# Cottam Solar Project

### Figure 8.16.8: Landscape and Ecology Mitigation and Enhancement Plan – Cottam 2 Revision A

Prepared by: Lanpro  
October 2023

PINS reference: EN010133  
Document reference: EX1/C6.4.8.16.8\_A  
APFP Regulation 5(2)(a)

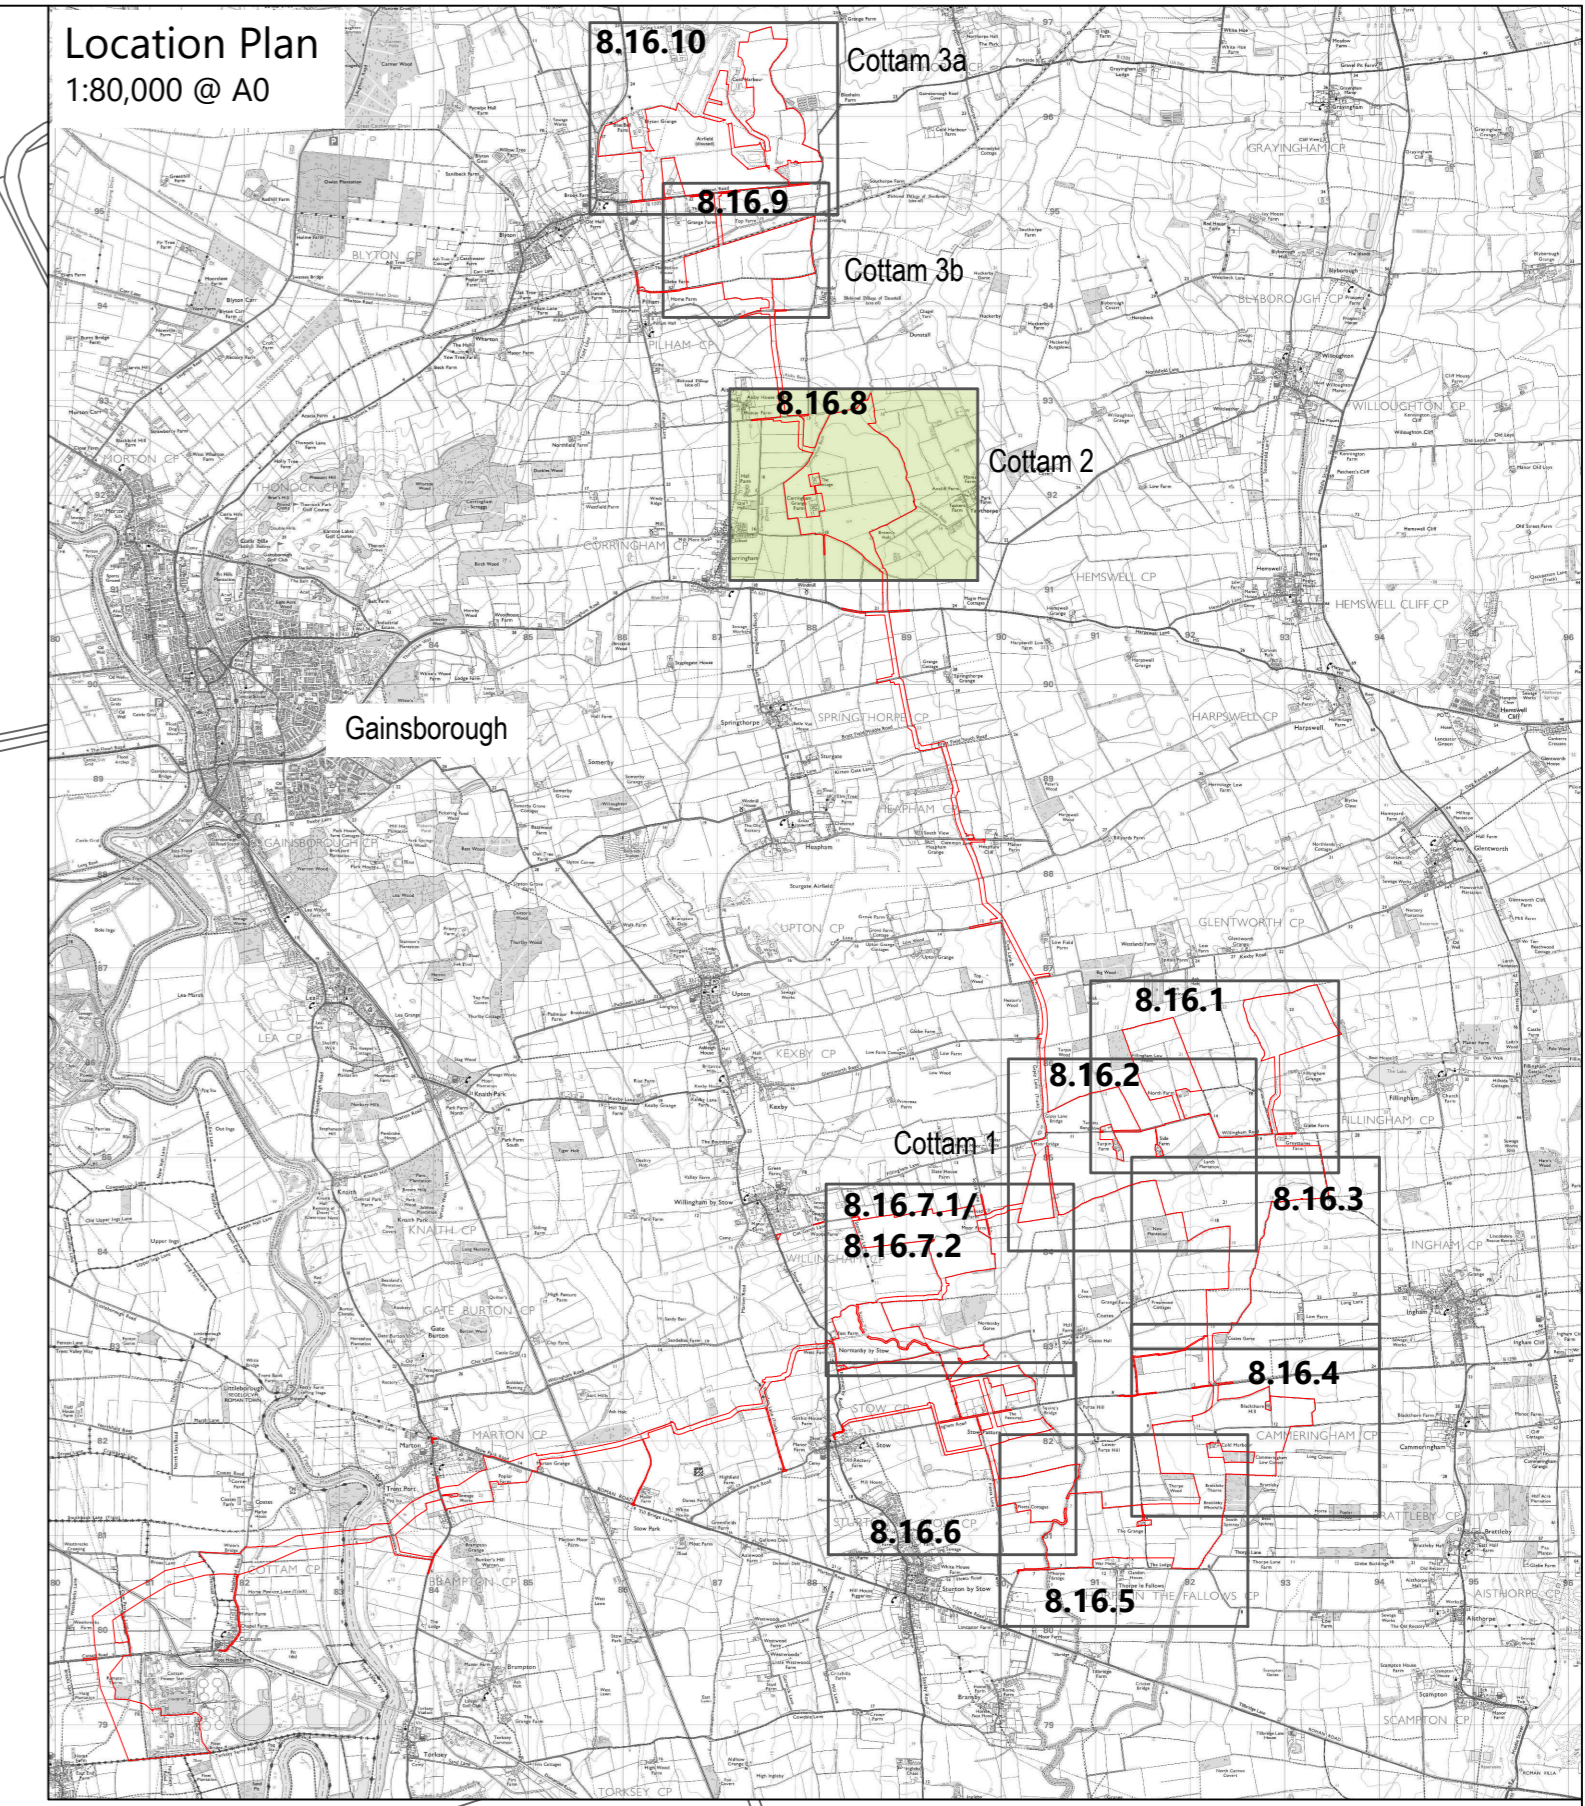
Figure Reference	Page	Description of Changes	Reason for Revision
Figure 8.16.8	3	Change to spelling of 'enhancement'. Offset calculations from drains.	For clarity and to correct a typo.
